CITY OF DOVER

PLANNING TECHNICAL REVIEW COMMITTEE –AGENDA

PLAN SNAPSHOT REPORT SITE-2025-0017 FOR CITY OF DOVER, N.H.

Re: SITE-2025-0017: 14 Industrial Park Road, Tax Assessor's Map G, Lot 4
Response to Technical Review Committee Comments, dated October 23, 2025

**ARCHITECTURAL SITE
PLAN & PROPOSED
BUILDING FLOOR PLAN**

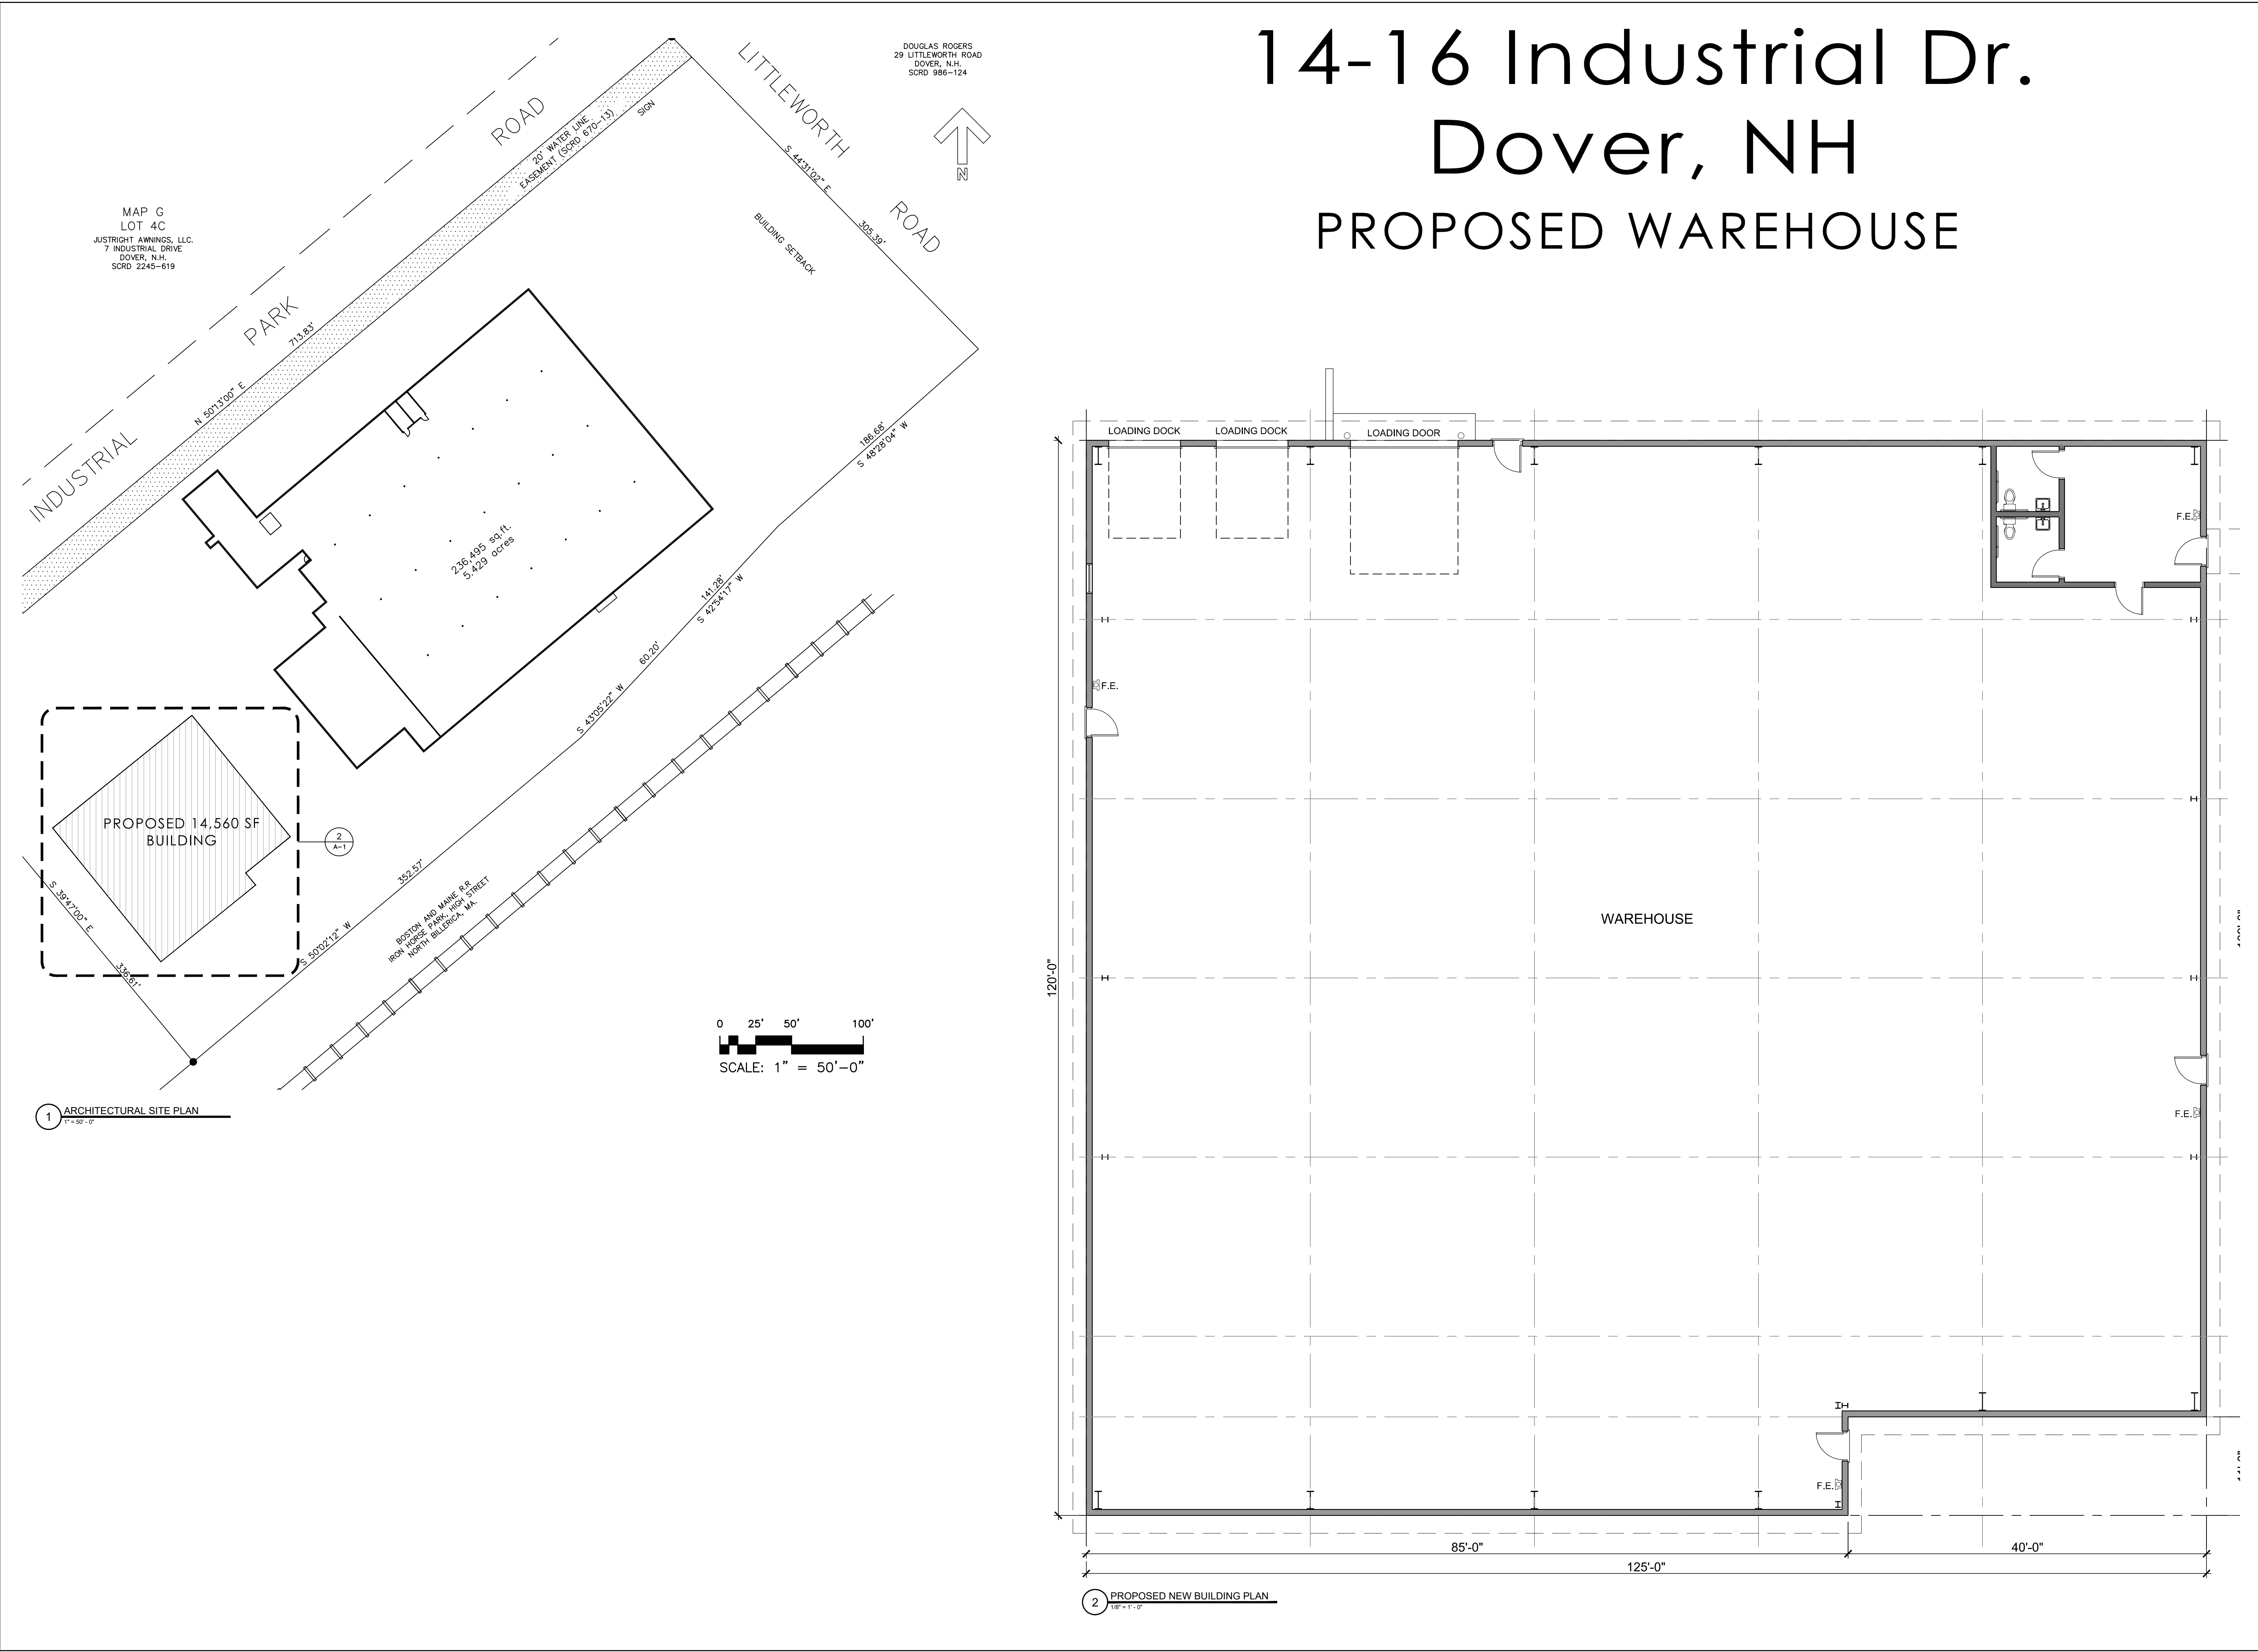
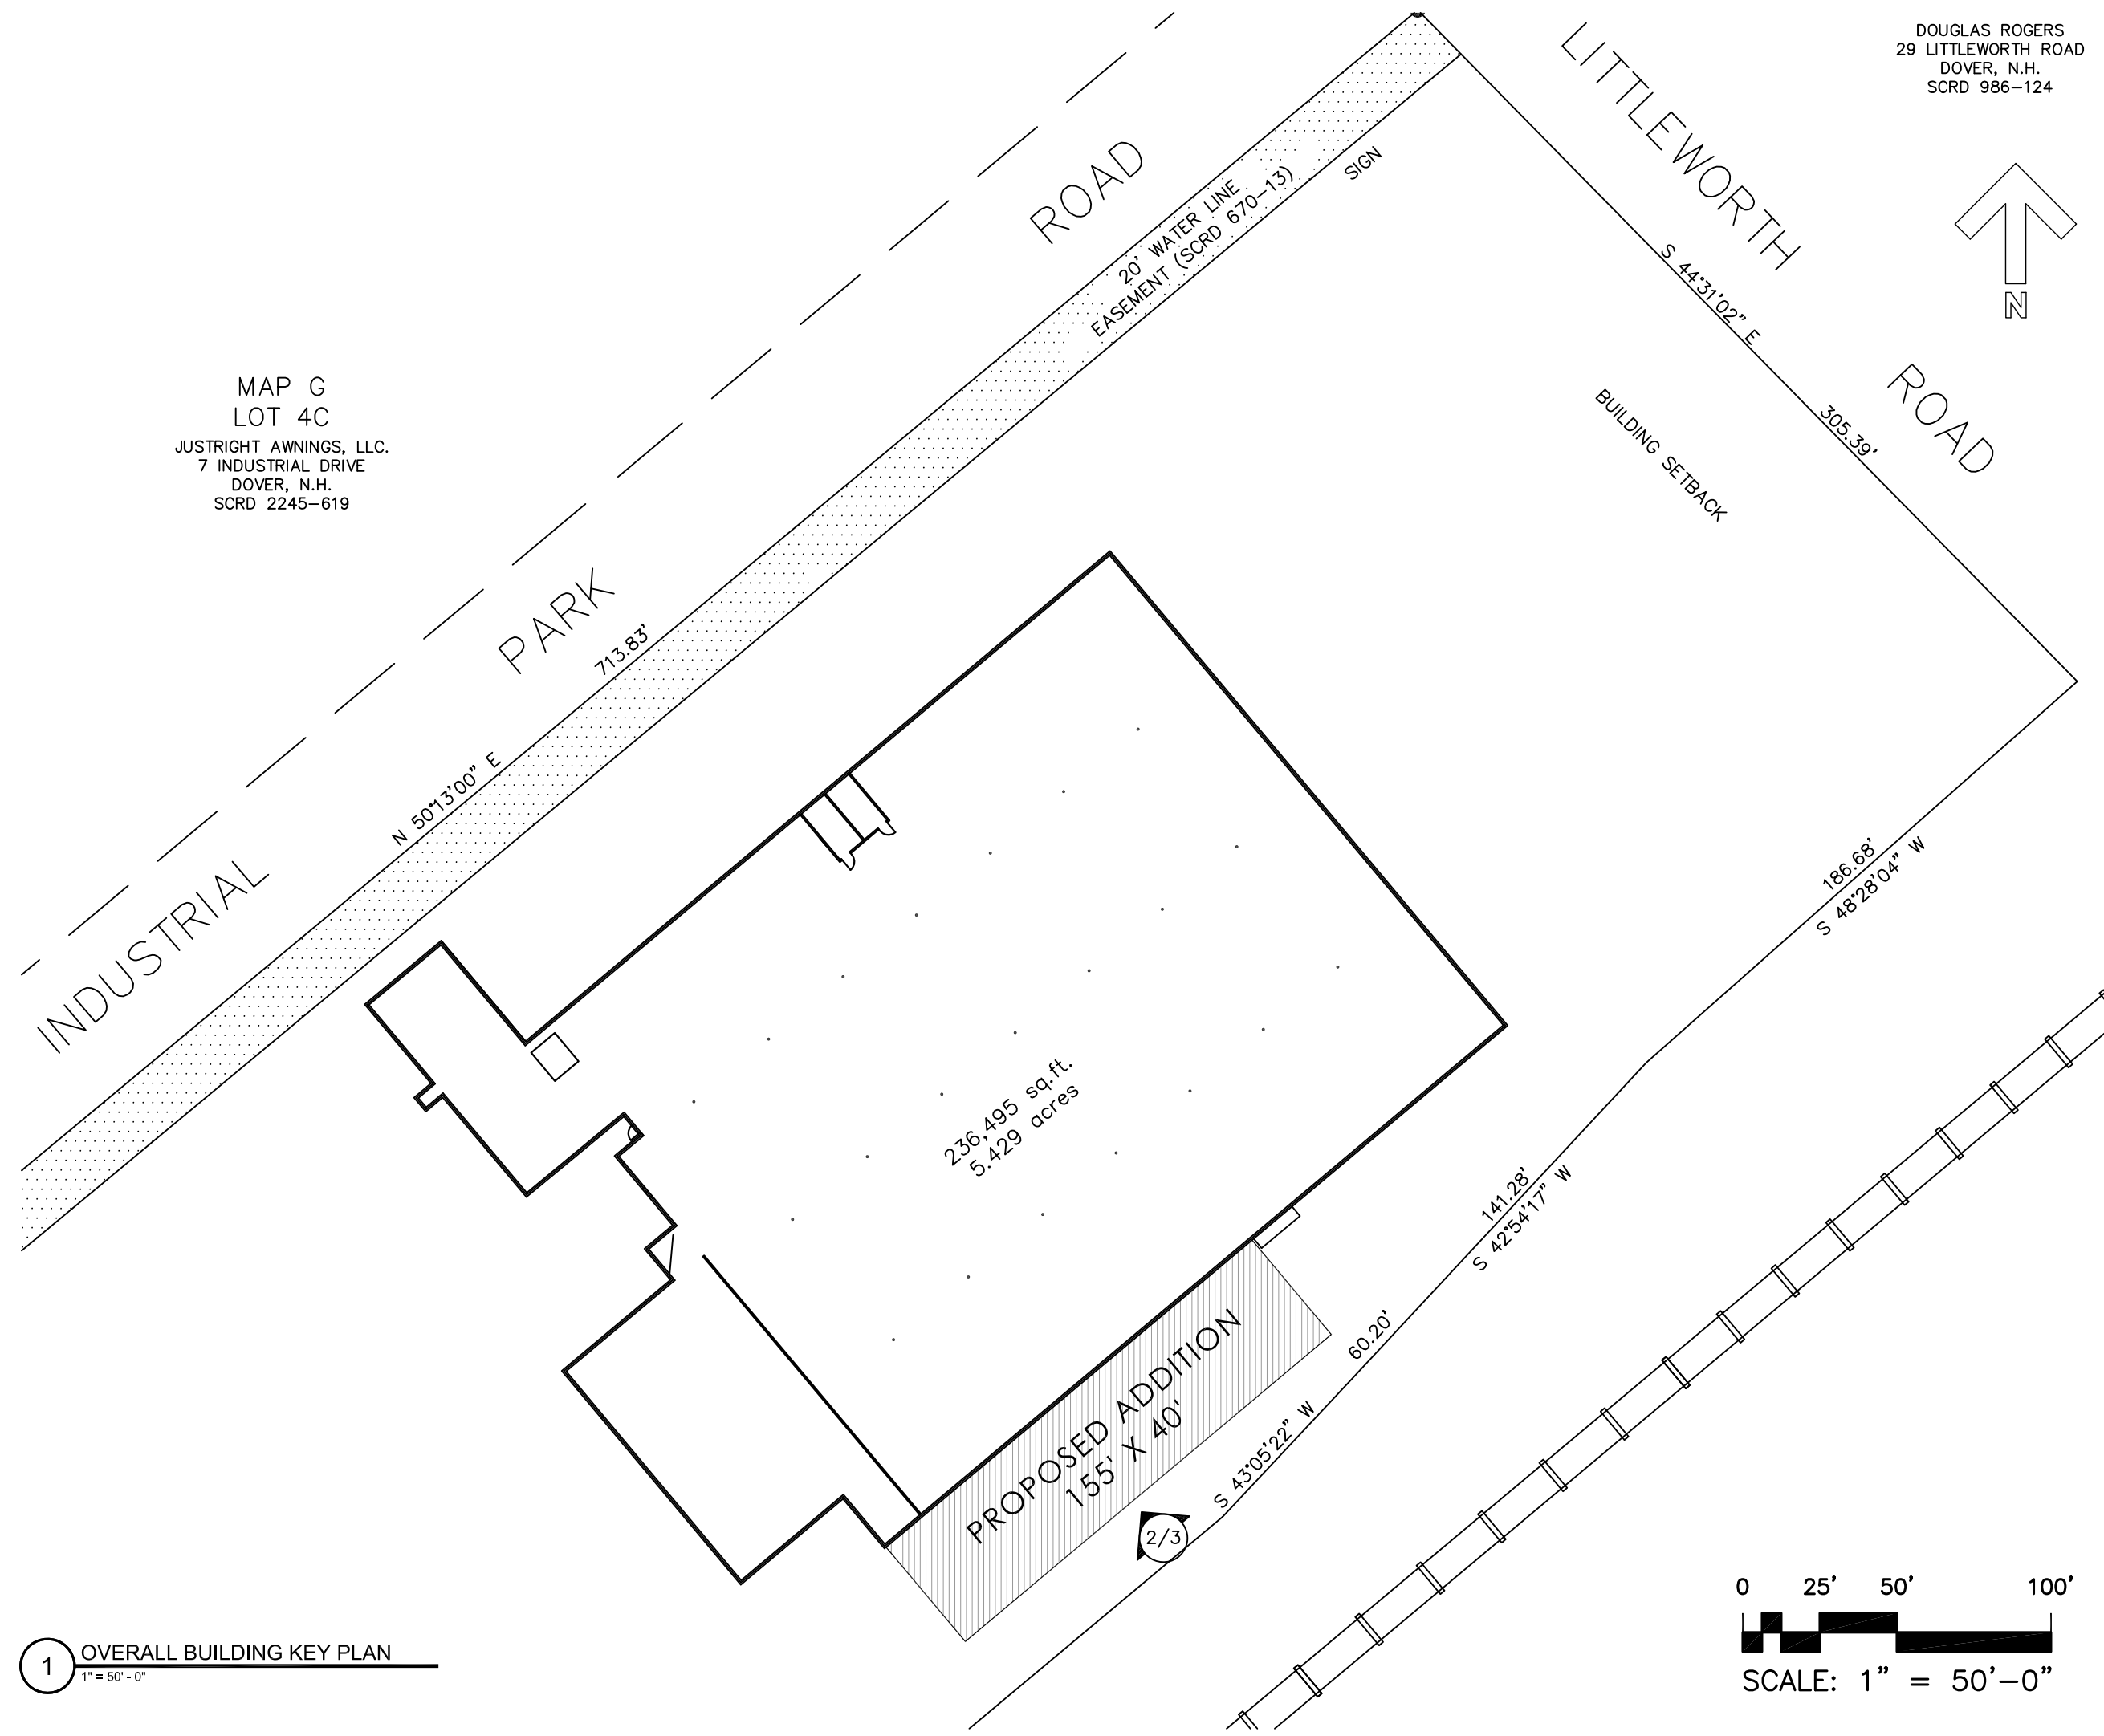
- Clarify addition use, accessible EV charger location, floor plan, means of egress, exit discharge.

- c. *floor plan,*

The plans have been updated to include a floor plan.
